Architectural Review and
Historic Preservation Board
Agenda Report

File: AR 15-26

RE: Architectural Review 15-26 (LaSalle's/Griffith) - 229 and 233 Broadway
Facade remodel and new outdoor dining patio

SUNPAK® INFRARED HEATERS

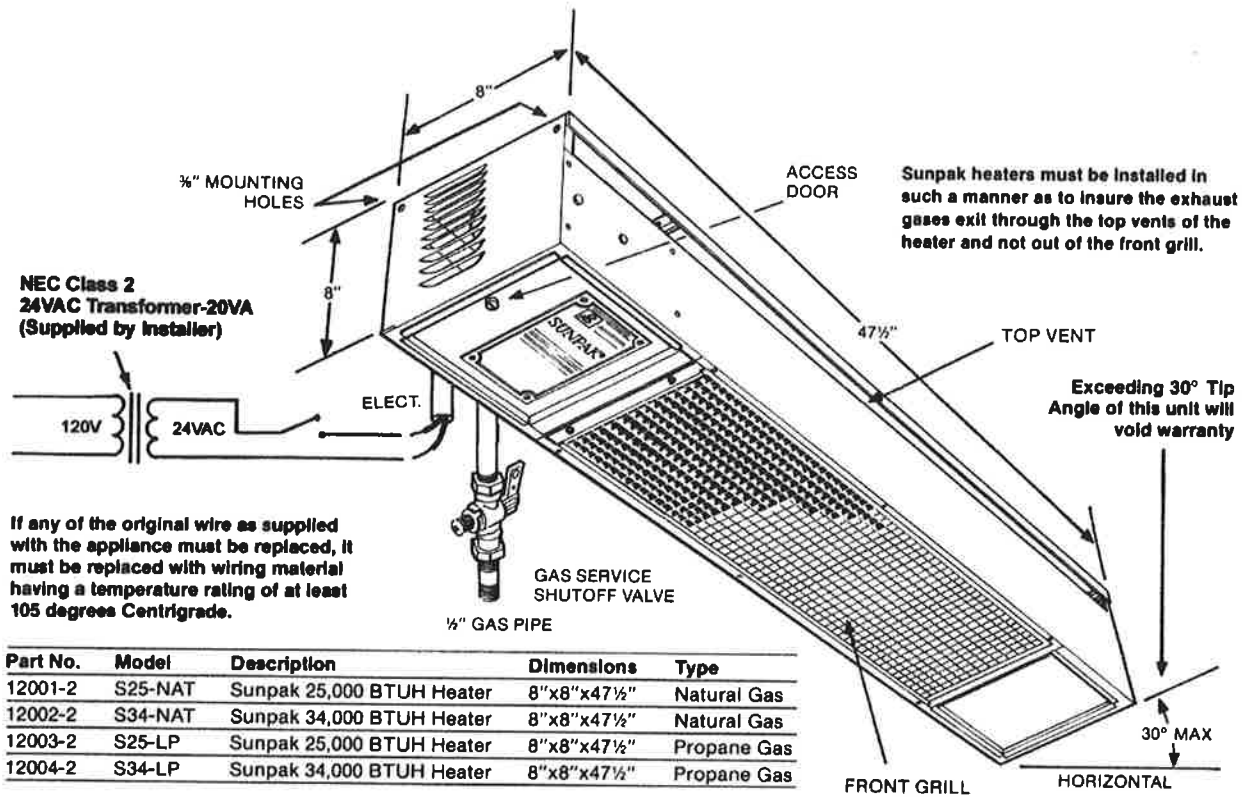
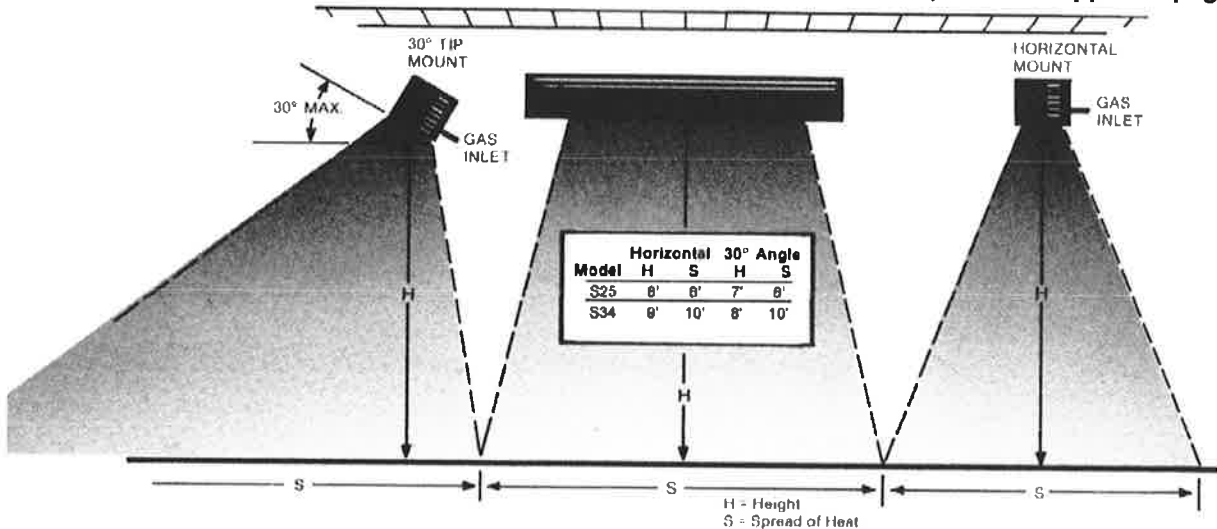
10. *Provide cut sheets and/or diagrams of heating fixtures.*

Staff response: Cut sheets provided appear to be consistent with those installed at the Tres Hombres and Burgers & Brews dining patios, and should not adversely affect the patio aesthetics.
